## PLANNING AND ZONING BOARD STAFF REPORT

### The Edge at Pineapple Grove

Meeting	File No.	Application Type
September 17, 2024	2022-008-SPF-SPR-CLV	Level 4 Site Plan
Applicant	Property Owner	Authorized Agent
Downtown Second Street, LLC	215 NE 6 <sup>th</sup> Ave, LLC	Dunay, Miskel & Backman, LLP

Provide a recommendation to the City Commission on a Level 4 Site Plan (including a Landscape Plan, Architectural Elevations, and Waiver) to construct a seven-unit townhouse development.

Previous Proposal: sole egress and ingress from NE 2<sup>nd</sup> Street

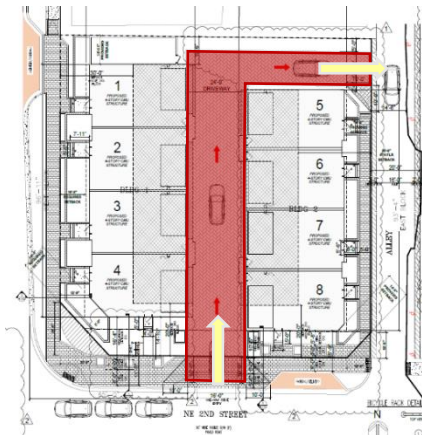
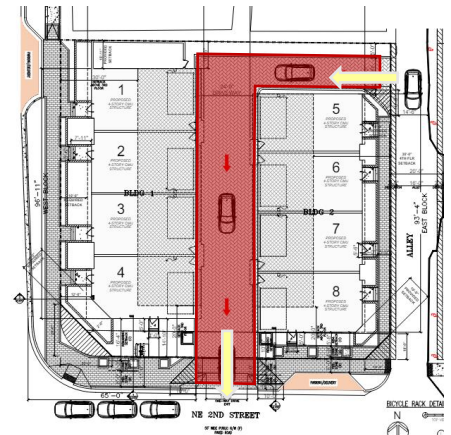
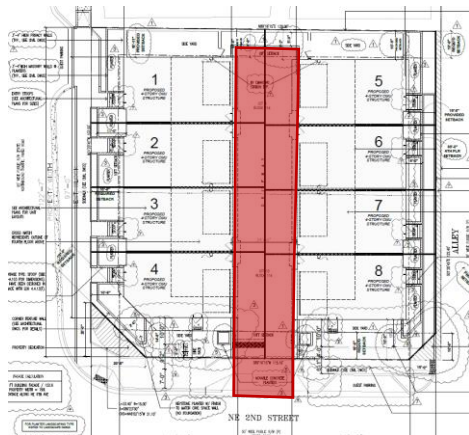
The applicant revised the vehicular access by providing sole ingress from NE 2<sup>nd</sup> Street and egress onto the alley. PZB reviewed the waiver request for vehicular access from a Primary Street and recommended approval, 5-2, with the condition that the ingress is from the alley and the egress is onto NE 2<sup>nd</sup> Street.

Voting 4-1, Commission denied the waiver request for LDR Section 4.4.13(I)(3)(b)1., to allow vehicular access from a Primary Street (NE 2<sup>nd</sup> Street), rather than the alley, which should be the primary source of vehicular access to off-street parking. The applicant has revised the configuration of the site plan to propose no vehicular access from NE 2<sup>nd</sup> Street (excluding the gate entrance for emergency vehicles) and sole ingress and egress is from the alley. The revised configuration required the removal of one unit, for a total of seven units.

PZB Proposal: sole ingress from NE 2<sup>nd</sup> Street and sole egress from alley

New Proposal: sole ingress from alley and sole egress from NE 2<sup>nd</sup> Street

**NE 2<sup>nd</sup> Street (West Block)**

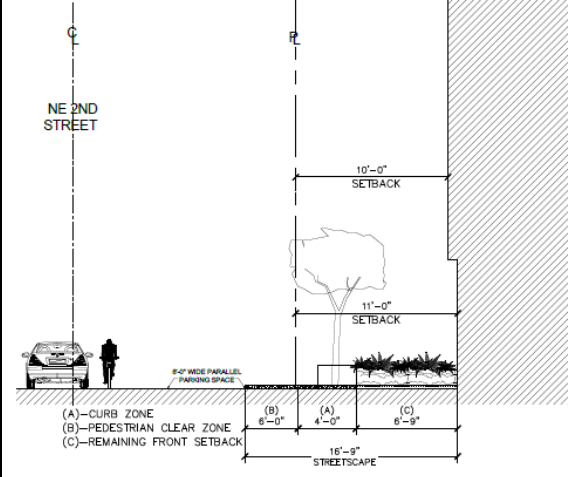
**Provided:** 16 feet, 9 inches (total)

**Curb Zone:** 4 feet

**Ped. Clear Zone:** 6 feet

**Front Setback Area:** 6 feet, 9 inches

**NE 2<sup>nd</sup> Street (East Block)**

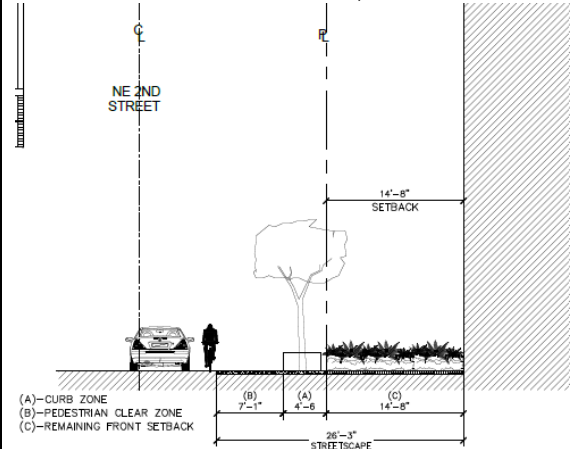
**Provided:** 26 feet, 3 inches (total)

**Curb Zone:** 4 feet, 6 inches

**Ped. Clear Zone:** 7 feet, 1 inch

**Front Setback Area:** 14 feet, 8 inches

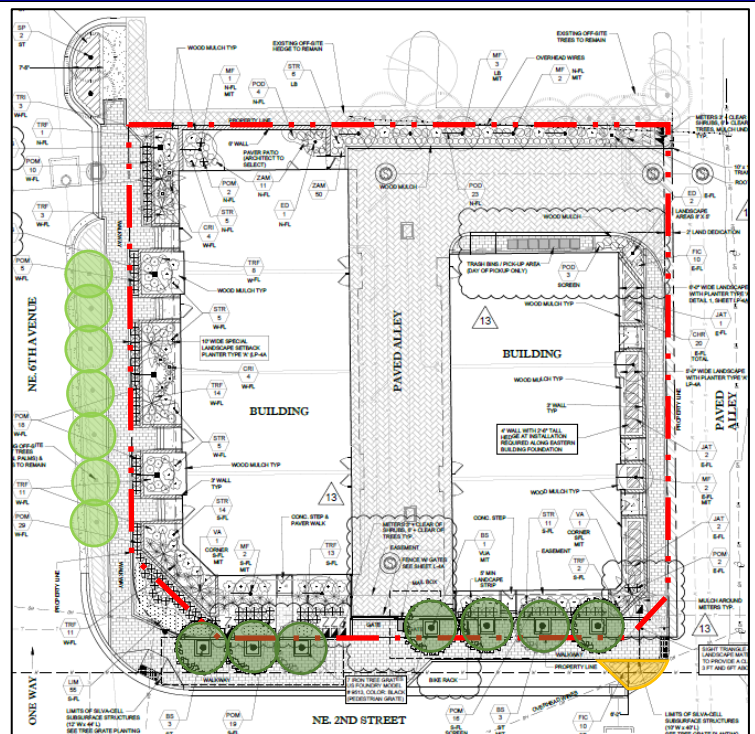
The project also includes waiver request from the requirements in **LDR Section 4.6.16(H)(3)(i)**, for relief to the required shade tree to be planted in the landscape island on the southeast corner adjacent to the parallel parking spaces along NE 2<sup>nd</sup> Street, shown in yellow.

The proposal includes three on-street parallel parking spaces, two spaces on NE 2<sup>nd</sup> Street and one space on NE 6<sup>th</sup> Avenue. The parking spaces shall be terminated by a landscape island minimum of nine feet and 135 square feet. The applicant is requesting for relief to the required shade tree as the required tree would conflict with the existing underground utilities. As the landscape is limited due to the existing watermain, the proposed landscape island will be planted with green island ficus. The request is not anticipated to negatively affect the neighboring area or create unsafe conditions. The Board should consider if the request results in an inferior pedestrian experience along NE 2<sup>nd</sup> Street.
